Subject: Cable Tray Support Review Questions  
Comanche Peak Steam Electric Station  
Independent Assessment Program - Phase 4  
Job No. 84056

CABLE TRAY SUPPORT REVIEW QUESTIONS

FIGURE 2A - TYPICAL TRAY CLAMP  
(NOT TO SCALE)

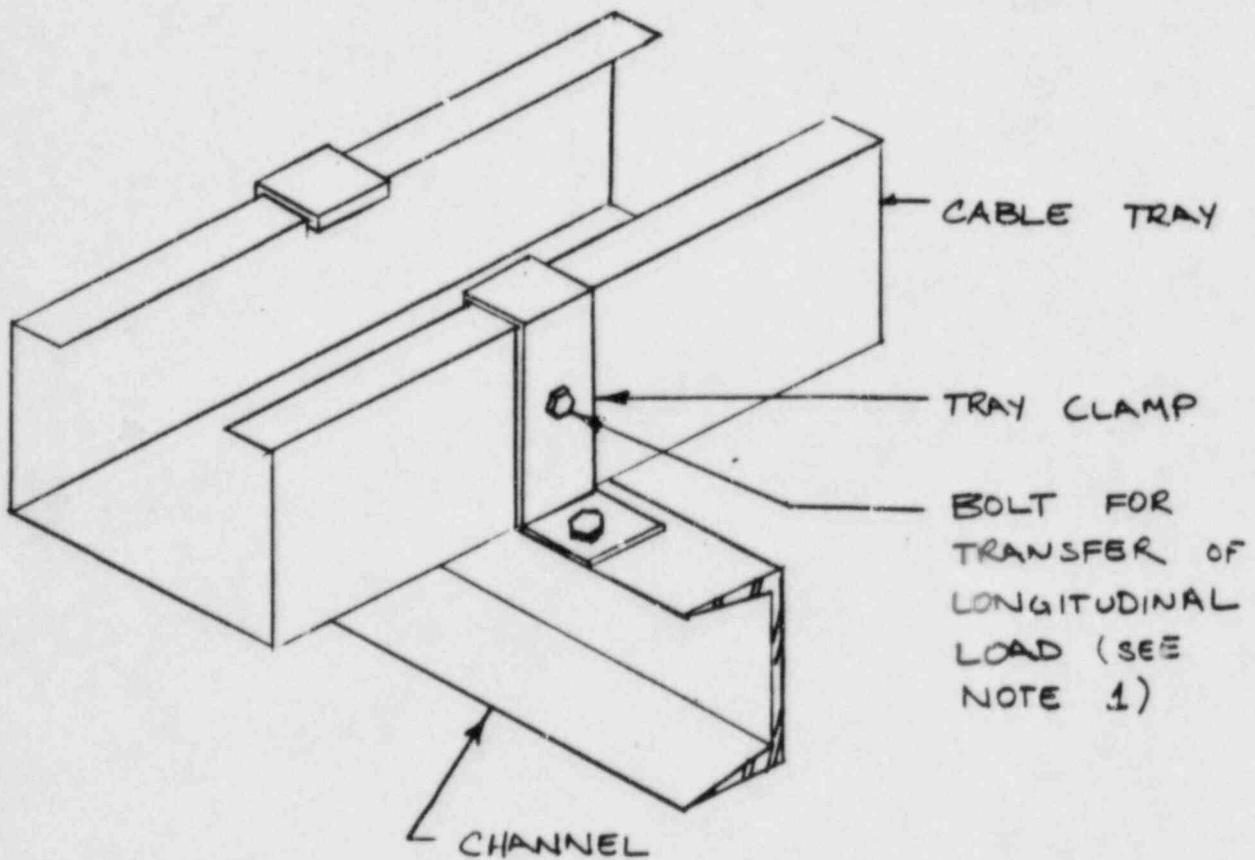
2.1 Cable trays are attached to supports by friction type or heavy-duty tray clamps. The former type resists transverse and vertical loads while the latter resists transverse, vertical and longitudinal loads. The connection details for these clamps require that they be bolted or welded to the top of the cable tray support beam. A typical connection is shown in Figure 2A. Such connections provide a load transfer which is eccentric to the major axis and to the shear center of the channel sections typically used in the cable tray support designs. As a result, several effects are not considered in the design of the supports.

Please provide Cygna with documentation showing the cable tray supports are capable of resisting the applied loads when the effects of the eccentricities described above are considered.

FIGURE 2B - ECCENTRICITY OF TRANSVERSE  
LOAD  $P_h$  FROM MAJOR AND  
MINOR AXIS OF A CHANNEL  
(NOT TO SCALE)

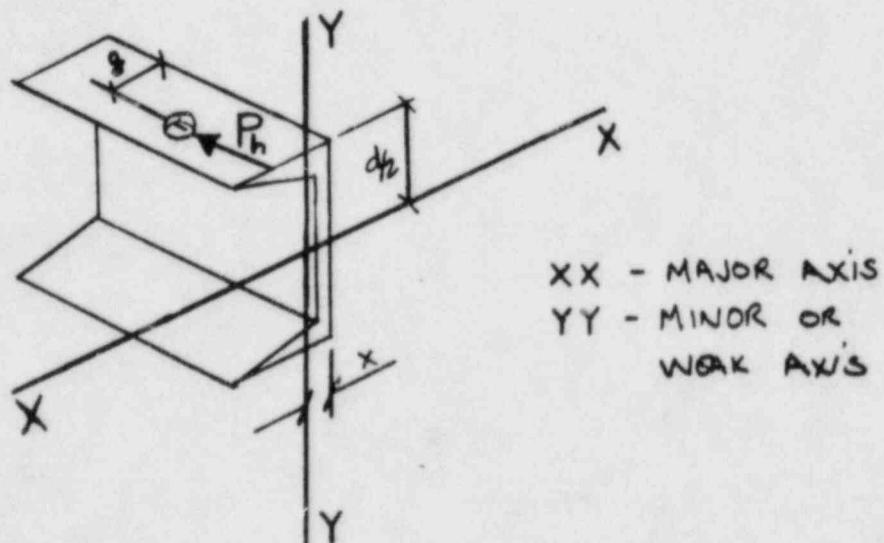
As noted in Figure 2B, the location of the transverse load,  $P_h$ , is eccentric to the major axis by a distance  $d/2$ , where  $d$  is the channel depth. The effect of this eccentricity is an increase in major axis bending. Minor axis bending will occur because  $P_h$  is eccentric to the minor axis by a distance of  $(g-x)$  where  $g$  is the gage distance and  $x$  is the location of the neutral axis relative to the back of the channel web.

FIGURE 2C - ECCENTRICITIES OF VERTICAL  
AND LONGITUDINAL LOADS  
(NOT TO SCALE)

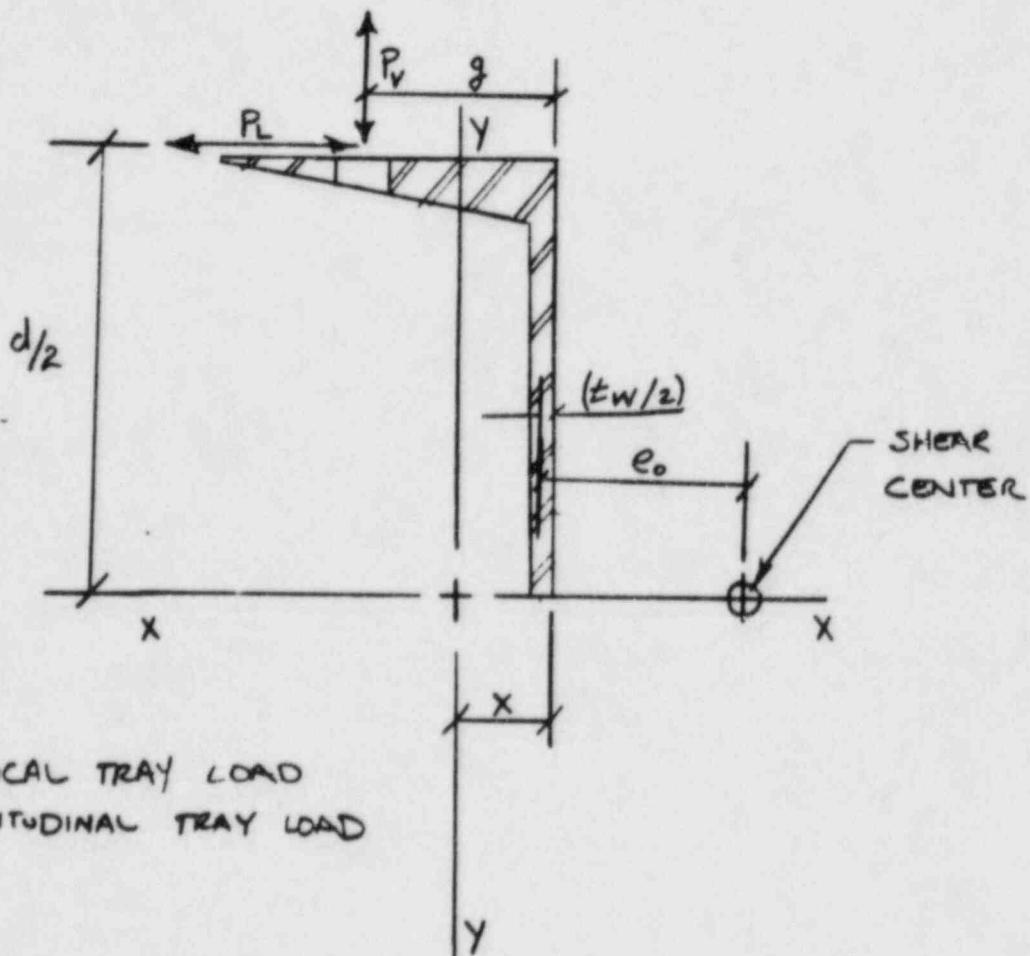
As shown in Figure 2C, vertical cable tray loads are applied eccentrically to the shear center of the channel section which induces torsional moments into the beam. Cygna has

noted that only beam members for Regular Case cable tray supports Details A<sub>j</sub>, B<sub>j</sub> and C<sub>j</sub> and Detail SP-7 with brace have been analyzed for the effects of eccentrically applied vertical loads. Cygna is currently reviewing these calculations. No other cable tray supports have been analyzed for the effects of torsion due to vertical loads.

As shown in Figure 2C, longitudinal cable tray loads are applied eccentrically to the major axis (X-X) of the channel section which induces torsional moments into the beam member. Cygna has noted that only Detail SP-7 with brace has been analyzed for the effects of eccentrically applied loads.

FIGURE 2D - ECCENTRIC MEMBER CONNECTION

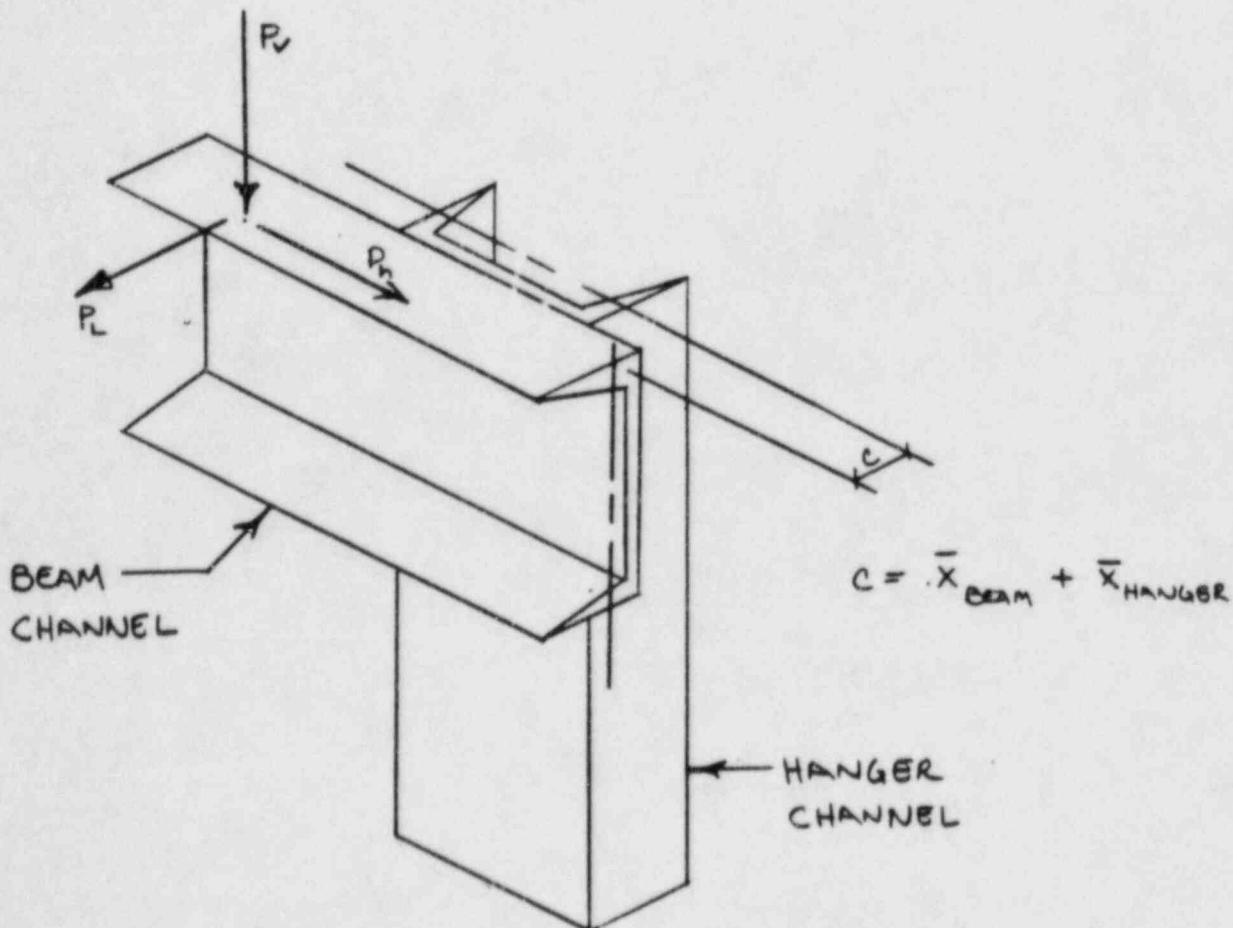
The cable tray supports are primarily constructed of channel sections for the hanger and beam members and angles for bracing members. (For Cygna's concerns regarding angles, reference Cygna's letter 84056.027, question 2.) Figure 2D shows the eccentricity between the neutral axis of a typical beam and hanger connection. Cygna has noted that the effect of this joint eccentricity has not been considered in the design calculations.
